# UNITED STATES PATENT AND TRADEMARK OFFICE

<b>Advisory Action</b> <b>Before the Filing of an Appeal Brief</b>	<b>Application No.</b> 10/816,993	<b>Applicant(s)</b> SMITH ET AL.	
	<b>Examiner</b> Alicia M Torres	<b>Art Unit</b> 3671

THE REPLY FILED 02 May 2005 FAILS TO PLACE THIS APPLICATION IN CONDITION FOR ALLOWANCE.

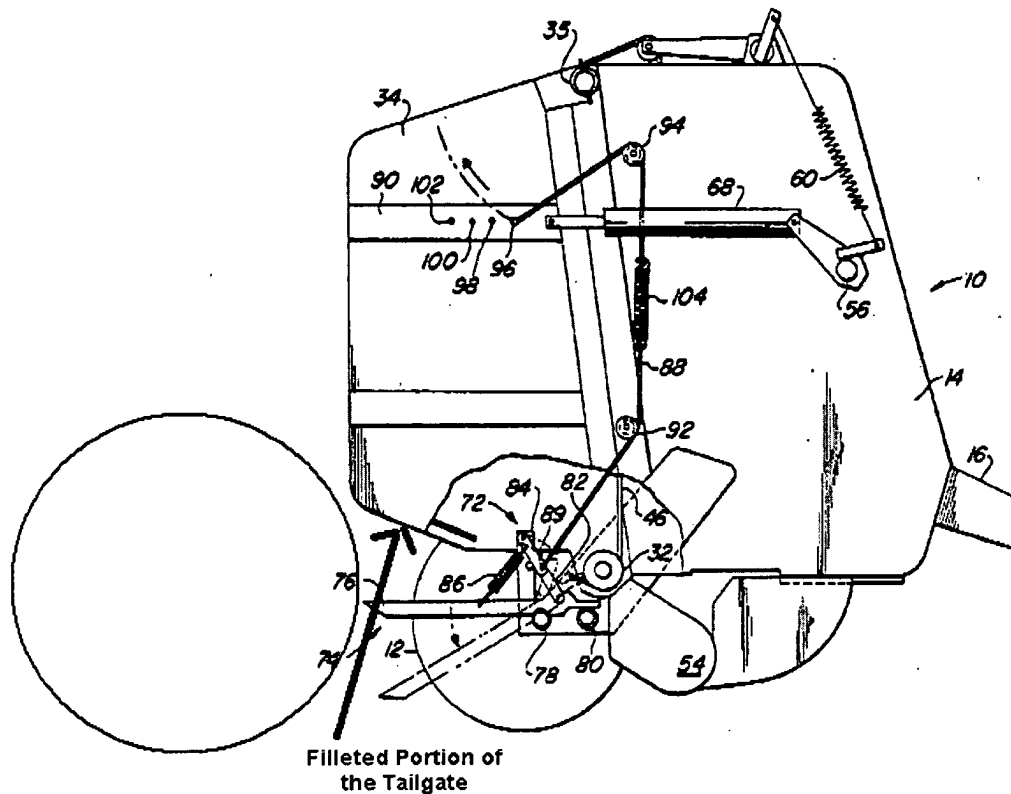
The claim language of the instant invention fails to disclose any specific structure, citing instead, many intended uses. Referring to what the applicant feels is the most critical part of the invention, the claim language requires that the ejection element have “a length long enough to hold a dumped bale sufficiently distant from the baler to allow the tailgate to close, while short enough to negate the need to be collapsible or to otherwise require additional adjustment.” There is no structure to that would preclude the use of Viaud in a rejection and because of the relative terminology (sufficiently, enough, allow) used, each case will be unique. For Viaud, the tailgate

is filleted, as shown below, which allows more room for the tailgate to swing closed if there were a bail present.

The lack of structure also allows for the case that the bale is of small size, so that the bale height doesn't reach the swing arc of the tailgate. There is also the case that the inertia when dumping the bail throws the bail out of reach of the tailgate. The phrase "allow" also poses a problem in that while a bale may be in the way and even make contact with the tailgate, most hydraulically driven tailgates will still be able to close.
